ADDENDUM No. 2

RFP No. 24-23

Barton/Bandemer Park Pedestrian Tunnel Project

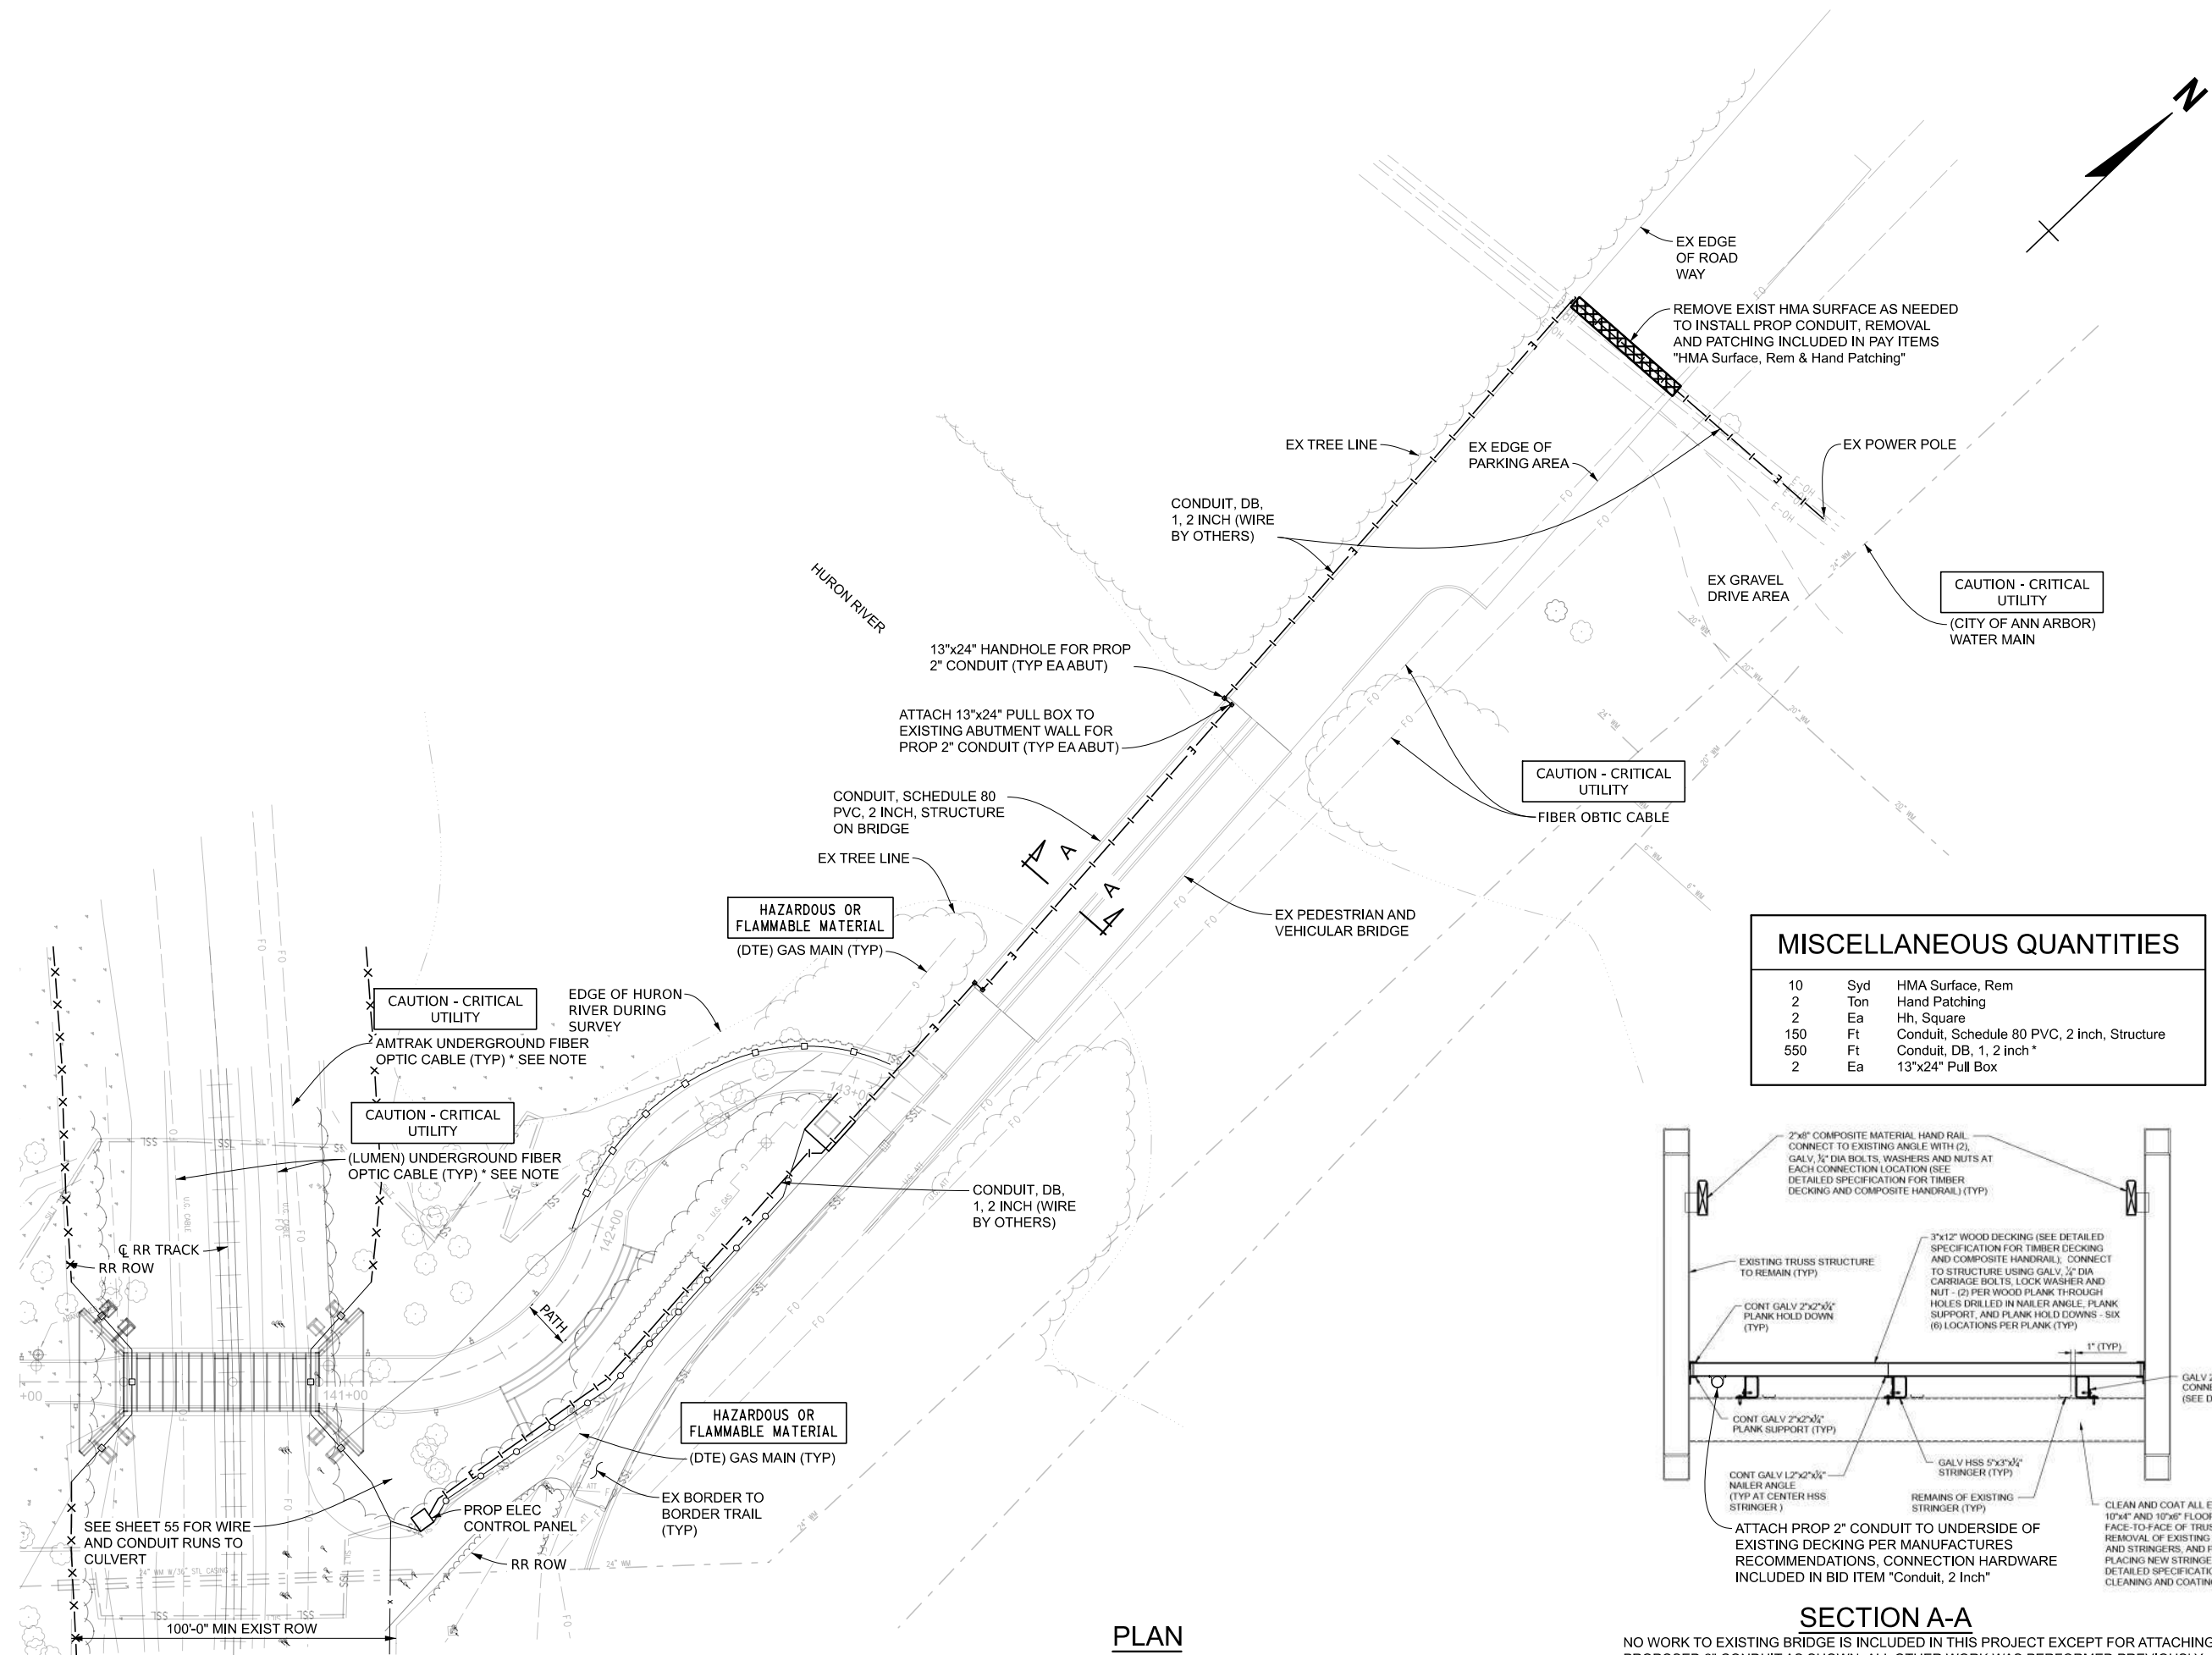
Replace plan sheet. Added note to right column of bottom table for Type A fixture.

PLAN
SHOWING EXISTING AND PROPOSED TOPOGRAPHY

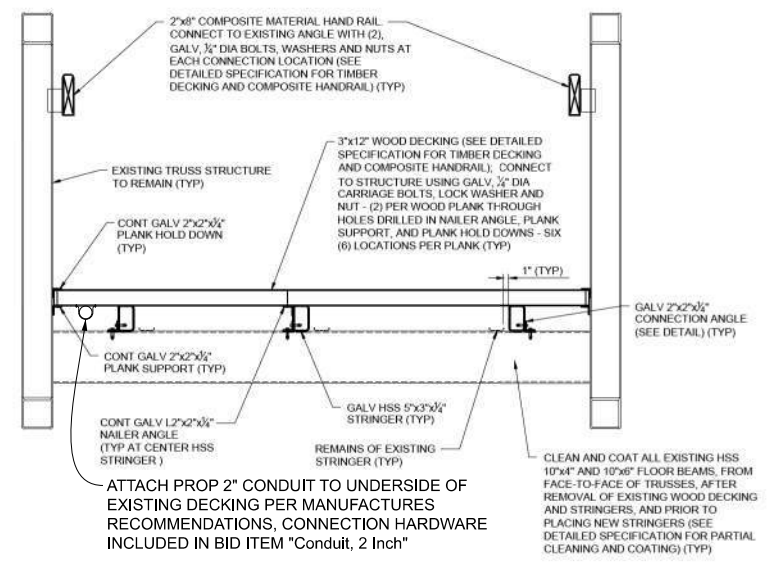
Replace plan sheet. Clarified conduit type in plan view to the control panel. Referred details to sheet 55 for conduit and wiring required from the control panel to the fixtures. Clarified there is no work to the existing park bridge except to attached conduit to it (added note below title of detail).

SECTION A-A
NO WORK TO EXISTING BRIDGE IS INCLUDED IN THIS PROJECT EXCEPT FOR ATTACHING THE PROPOSED 2" CONDUIT AS SHOWN. ALL OTHER WORK WAS PERFORMED PREVIOUSLY.
